Work Order ID 138249***138249***

Item Name: Seat Structure Assembly

DRAWING NO. D3016	TITLE SEAT FRAME ASSEMBLY	REV. A	DART AEROSPACE LTD ENGINEERING ORDER	D.E.O. NO. D3016-A-1	SHEET NO. SHEET 1 OF 1	SCALE NTS
DRAWN <i>8</i>	CHECKED <i>UP</i>	MFG. APPR. <i>R</i>	APPROVED <i>MP</i>	DE APPR. <i>MP</i>		
DATE 10.01.29	DATE 10.01.29	DATE 10.01.29	DATE 10.01.29	DATE 10.01.29	DATE 10.01.29

D3016-11 SADDLE

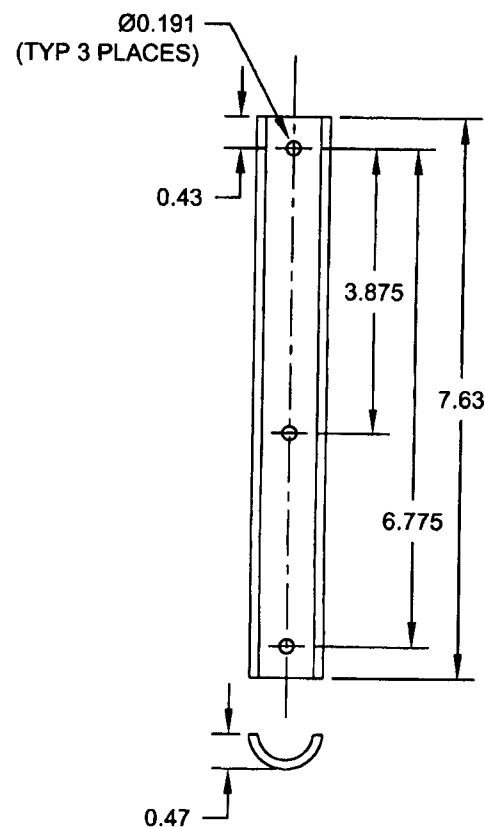
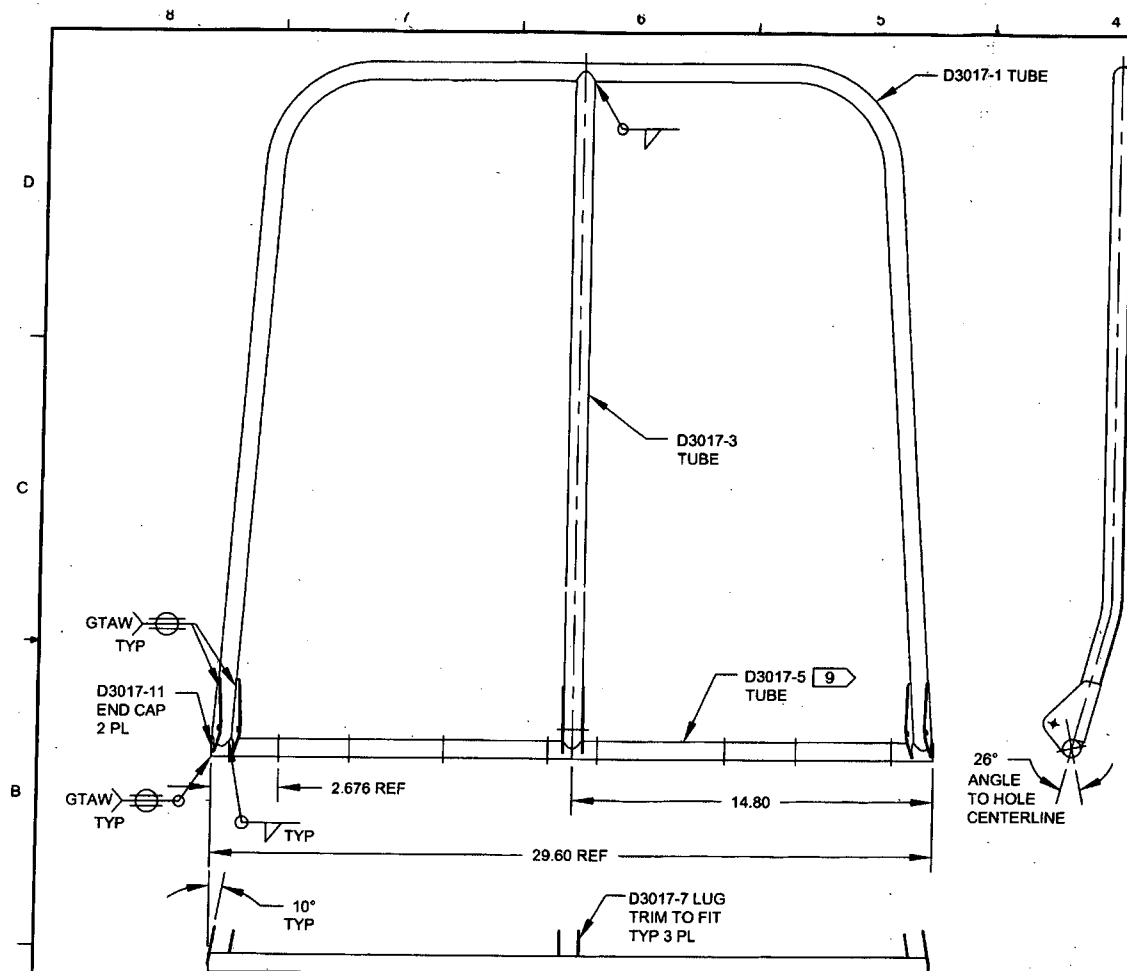
TO REVISE D3016-11 SADDLE'S HOLE SIZES

DETAIL D3016-11 SADDLE (SHEET 3): Ø0.257 TYP 3 PL WAS Ø0.191 (TYP 3 PLACES) AS SHOWN:
